HISTORIC AND DESIGN REVIEW COMMISSION

Agenda Item No: 24

HDRC CASE NO: 2015-135
ADDRESS: 932 BURNET ST
LEGAL DESCRIPTION: NCB 1659 BLK G LOT 13
ZONING: R6 H
CITY COUNCIL DIST.: 2
DISTRICT: Dignowity Hill Historic District
APPLICANT: Ntando McIntosh
OWNER: Ntando McIntosh
TYPE OF WORK: Construct a three story, three car garage
REQUEST:

Concept Elevation Drawings

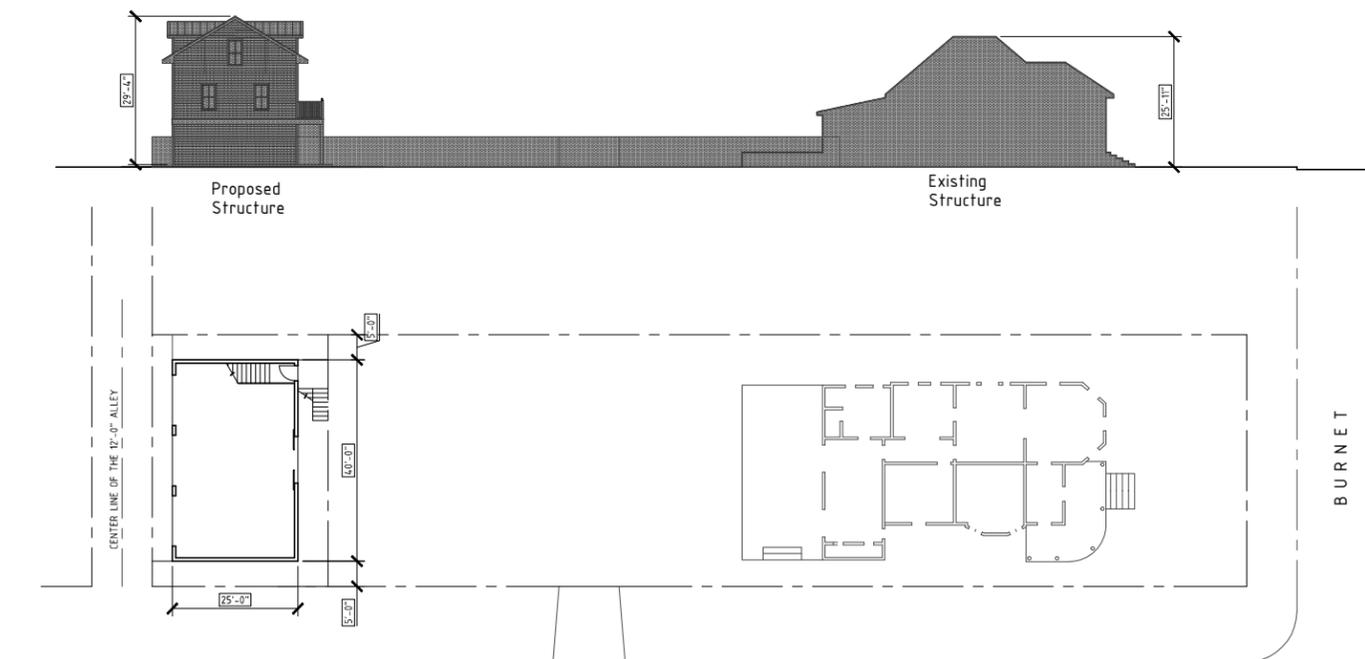
- c. This request was heard a third time by the Design Review Committee on October 14, 2015, where committee members noted that the overall height of the accessory structure is inappropriate, that an accessory structure should be subordinate to the primary historic structure, that the proposed dormers were too strong, that the overall height should be reduced and that the proposed massing was too impactful to the site.

- e. According to the Guidelines for New Construction 5.A., new garages and outbuildings should be designed to be visually subordinate to the primary historic structure in terms of their height, massing and form. At three stories and nearly the width of the entire site, the applicant's proposal is not consistent with the Guidelines.

- f. New accessory structures should not be larger in plan than 40 percent of the primary historic structure's footprint. With a footprint of 1,000 square feet, the applicant's proposal is not consistent with the Guidelines for New Construction 5.A.ii.

- g. The applicant has proposed materials to include Hardi Board siding and a standing seam metal roof. At this time the applicant has not specified materials for the proposed doors, garage doors nor windows. Staff recommends that the applicant install wood windows and doors as well as wood carriage doors to be consistent with the Guidelines for New Construction 5.A.iii., iv. and v.

Staff does not recommend conceptual approval based on findings d through g. Staff recommends the applicant propose an accessory structure that is consistent with the examples set throughout Dignowity Hill as described in the Historic Design Guidelines. The applicant's current proposal is not consistent with the Guidelines nor the example set throughout the neighborhood in terms of height, width, mass or scale.

COMMENTS/CONCERNS: AL HEIGHT OF PROPOSED ACCESSORY STRUCTURE IS INAPPROPRIATE - ACCESSORY STRUCTURE SHOULD BE SECONDARY IN STATURE TO THE PRIMARY HISTORIC STRUCTURE. PROPOSED ACCESSORY STRUCTURE READS AS THREE LEVELS. DORMERS ARE TOO STRONG - PRONOUNCE VISUAL HEIGHT. OVERALL HEIGHT SHOULD BE REDUCED. MASSING SHOULD BE LESS IMPACTFUL TO OVERALL SITE. MODEST HOUSE SHOULD HAVE A MODEST ACCESSORY STRUCTURE.
